# Product Change Notification

**Change Notification #:** 116340 - 00  
**Change Title:** Intel® Server Board S2600WFT,  
Intel® Server Board S2600WF0,  
Intel® Server Board S2600WFQ,  
PCN 116340-00,  
Product Design, Label,  
CPLD Motherboard Firmware upgrade and  
remove Li-Battery Label  
**Date of Publication:** June 28, 2018

Image of Li-Battery label

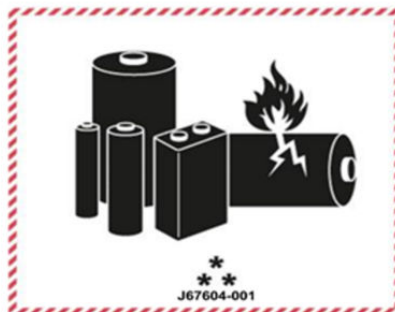
1. CPLD Firmware version has been upgraded from 0x0D to 0x0F, the new firmware includes a change into the CPLD code that improves Management Engine (ME) signal access to report more accurate watchdog timeout events.
2. Removing the Li-Battery label on the inner and outer box.
